**CITY OF CAMBRIDGE**  
**BOARD OF SURVEY**

Re: Board of Survey Report Pursuant to G.L. c.  
143, § 8 Re: Address: 221 Mount Auburn  
Street, Cambridge, MA.

## RIVERVIEW CONDOMINIUMS – SUPPLEMENT TO 27 JUNE 2025 SGH LETTER

Re: Board of Survey Report  
221 Mount Auburn Street, Cambridge, MA

**FIG. 1** – Count of slab-column connections by DCR range for full code-required gravity loading (envelope), showing categorizations (meets code, strengthening required, potentially dangerous) in accordance with IEBC and ACI 562.

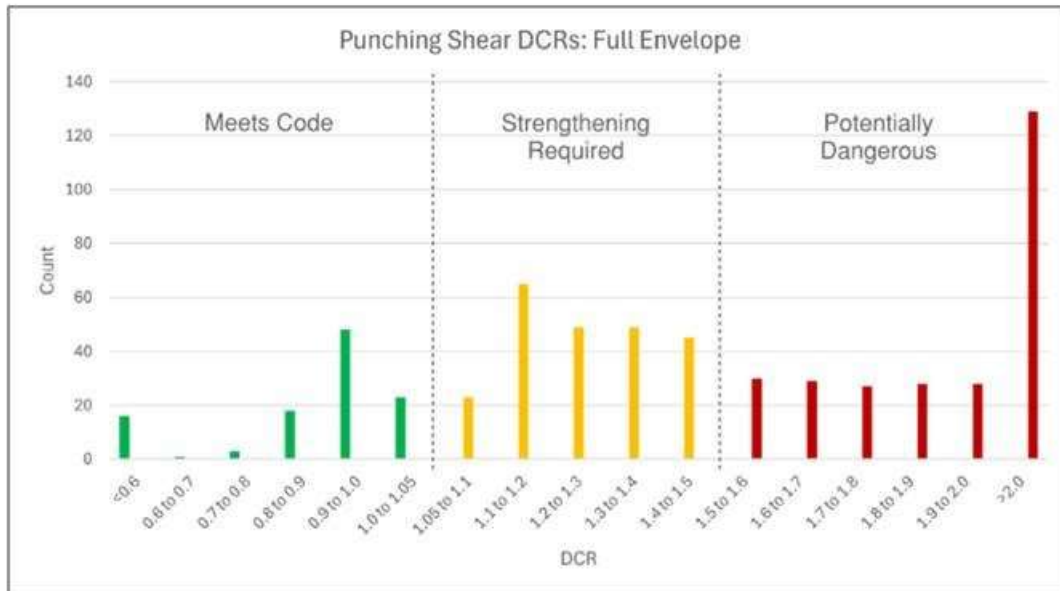
This June 27, 2025 Supplemental Letter prepared by SGH shared additional information requested by the City including **analysis of the building with dead load only (no snow load)**. The analysis shows a **significant number of slab-column connections** that are **potentially dangerous** (Demand to Capacity Ratios (“DCR”)  $>1.5$ , per American Concrete Institute (ACI) Code 562), **even without any snow load**. Figure 1 (1.4D load combination) shows that many column-slab connections have punching shear DCRs greater than 1.5 under dead-load only (i.e., the self-weight of the structure). Similarly, Figure 2 (1.2D + 1.6S load combination) also shows many locations with DCRs greater than 1.5, in particular at the High Roof and Low Roof slabs, due to snow loads. ACI 562 Commentary states that “the demand-to-capacity ratio for unsafe conditions was developed consistent with the performance-based procedures” contained in American Society of Civil Engineers and Structural Engineering Institutes – Minimum Design Loads and Associated Criteria for Buildings and Other Structures (ASCE/SEI 7-16)<sup>1</sup> and that “a demand-to-capacity ratio greater than 1.5...represents a condition with limited to no margin of safety against failure for ASCE/SEI loads.”

The Riverview Condominiums - Count of Slab-Column Connections by DCR report dated July 1, 2025 further examined the **magnitude of the number of potentially dangerous slab-column connections, both with and without snow load.**
